VILLAGE OF SUSSEX
SUSSEX, WISCONSIN

Minutes of the Architectural Review Board (ARB) meeting held on March 2, 2016.

MEMORANDUM

RE: ARB meeting for March 2, 2016

Date: 11-2015 Drawn By: B. Zenker
 Sheet Title: SITE PLAN
 Sheet Number: C-101
 Project Number: P11547

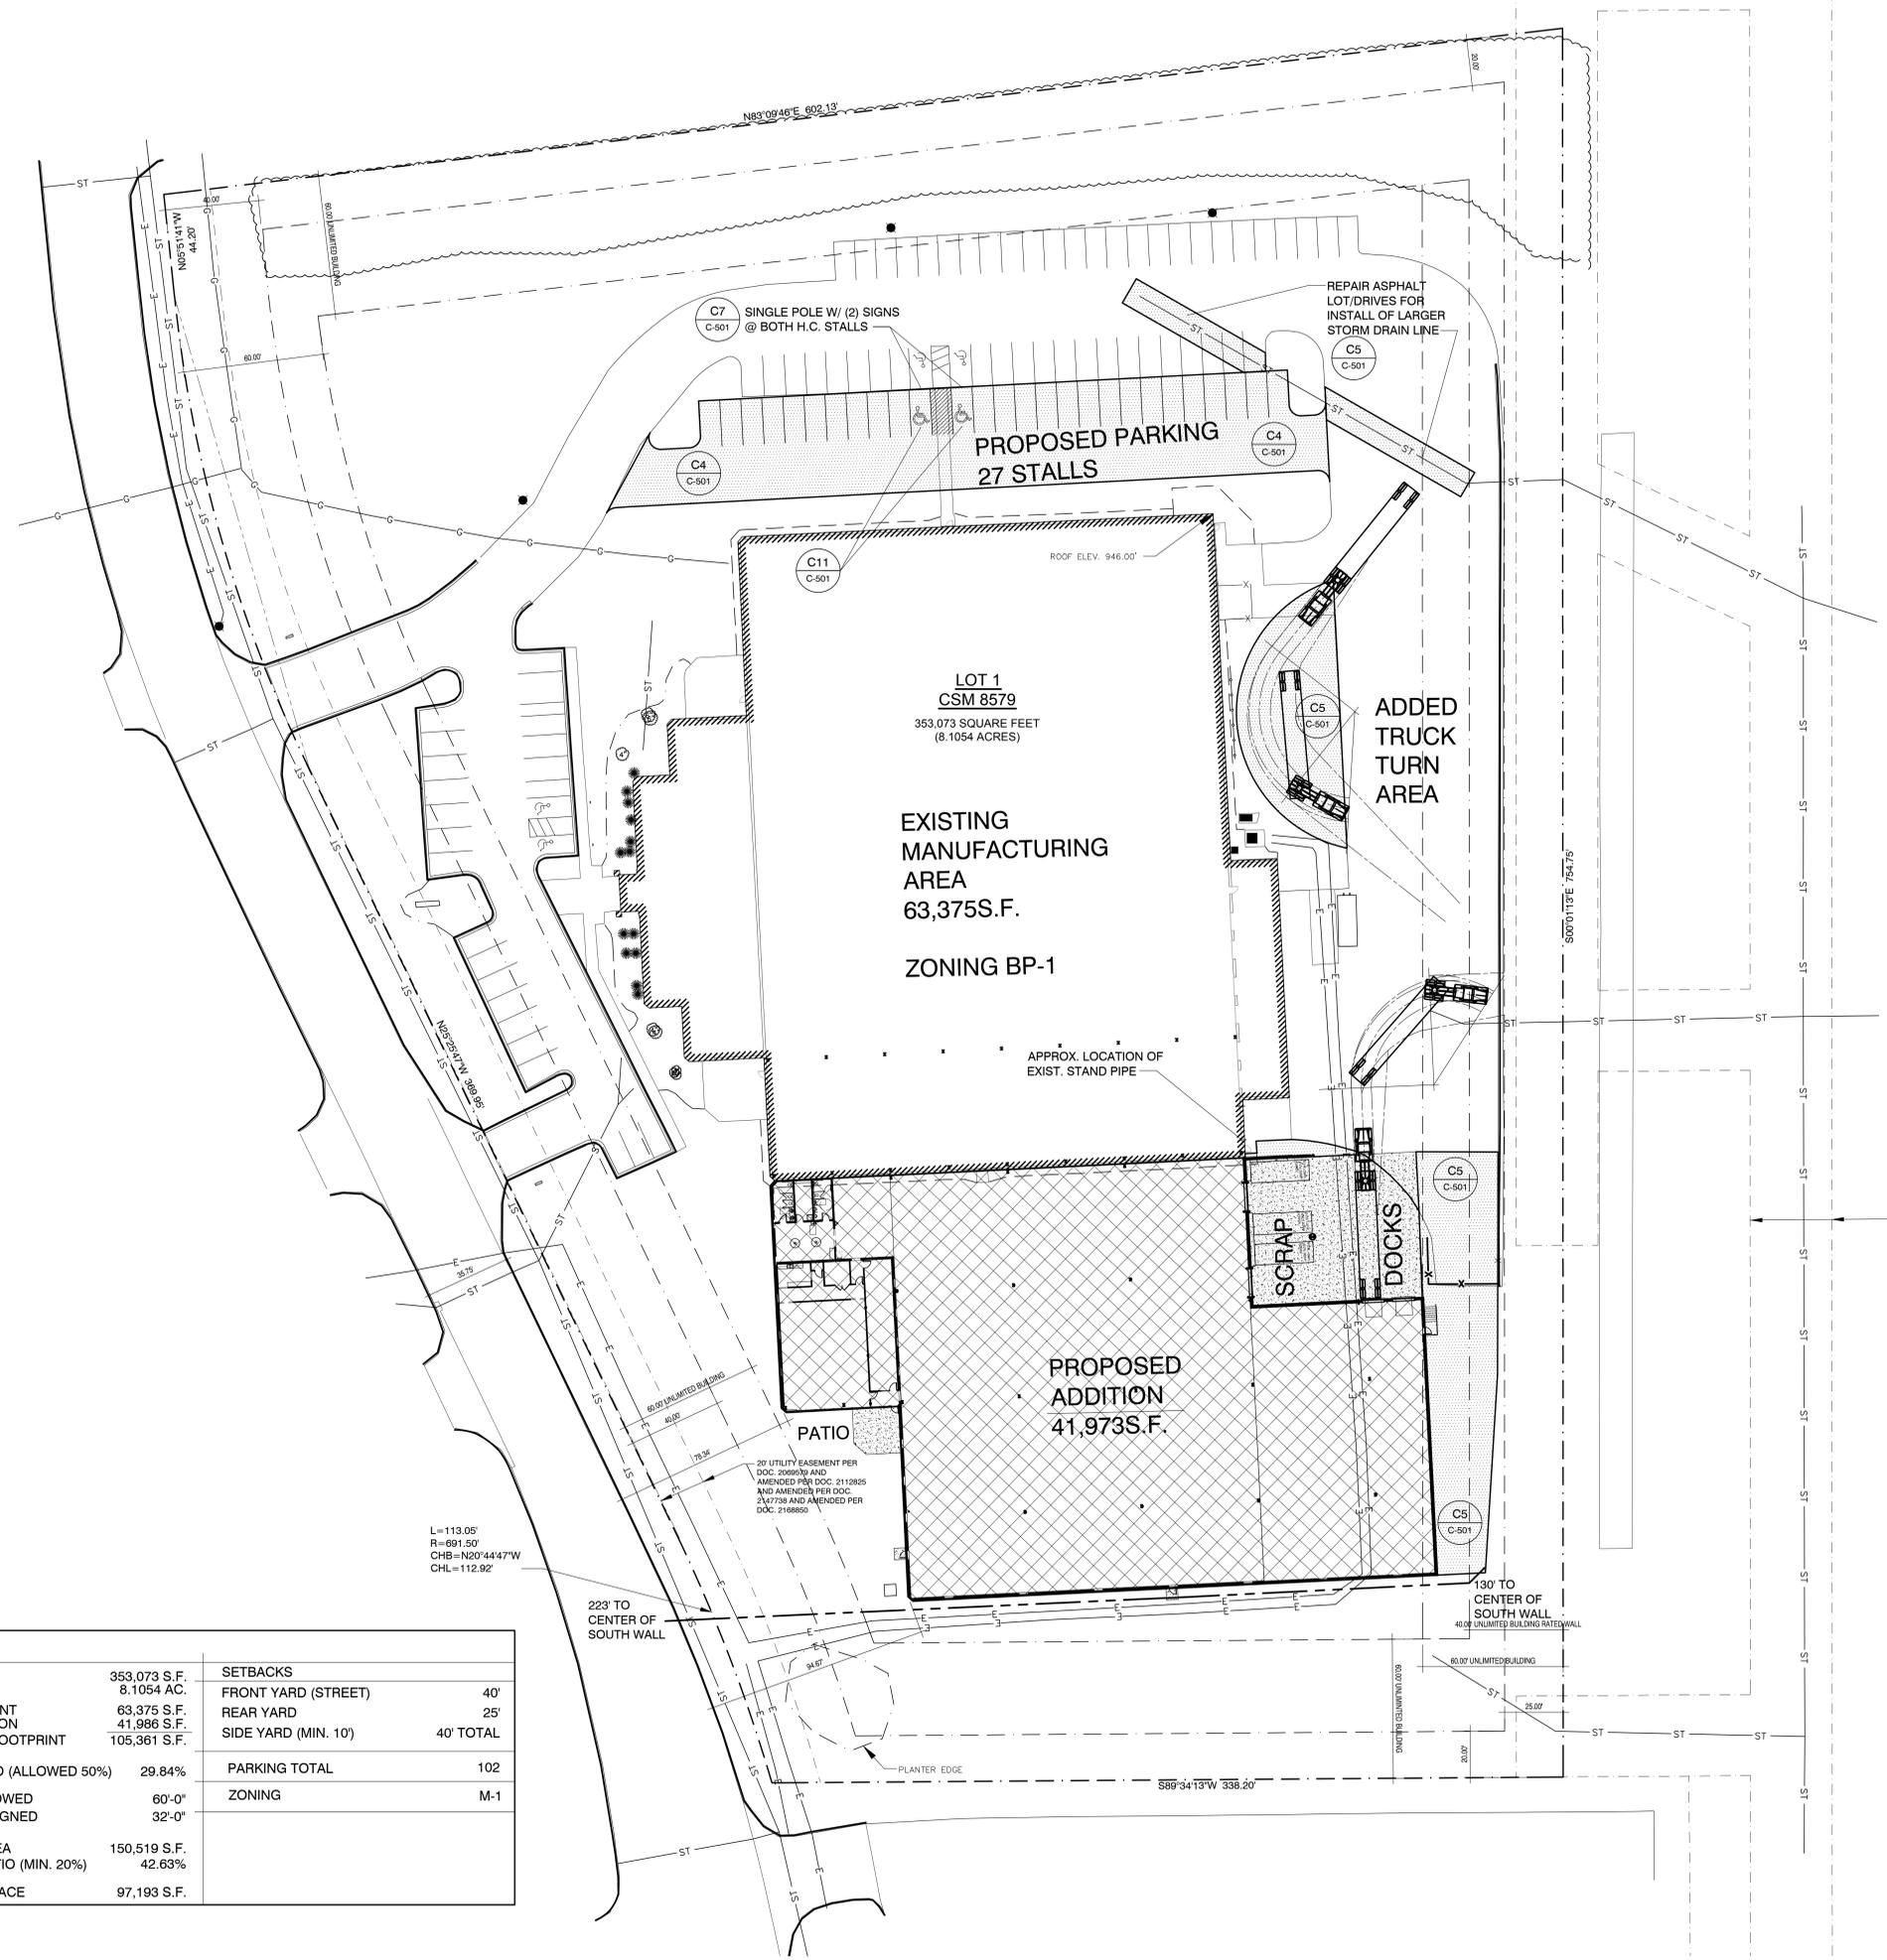
Mrs. Tetzlaff asked if this would create a different traffic pattern. Mr. Neumann stated the entrance to and from the site is the same and traffic to the site should be the same. Mr. Dietrich asked if there was enough room for the trucks to turn around. Mr. Neumann reviewed the site plan that shows the truck traffic pattern.

- Subject to final review by the Village Engineer.

Arm Mount and Wall Mount

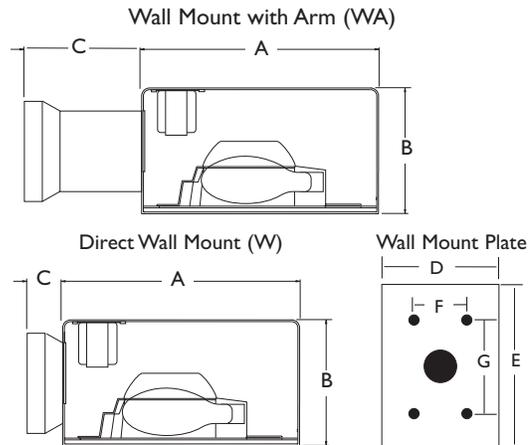
Mrs. Fluet read the memo (copy attached). Mrs. Fluet asked Mr. Neumann to address the comment in the memo about the wall mount or pole mount. Mr. Neumann stated it's a pole that is mounted on the building. Mrs. Fluet stated even though the pole is attached to the building it should not exceed the height of 30 feet.

- OB cut sheet indicates an arm mount and a wall mount, petitioner will need to explain which option will be used. Tools will match the new wall lights with the existing.
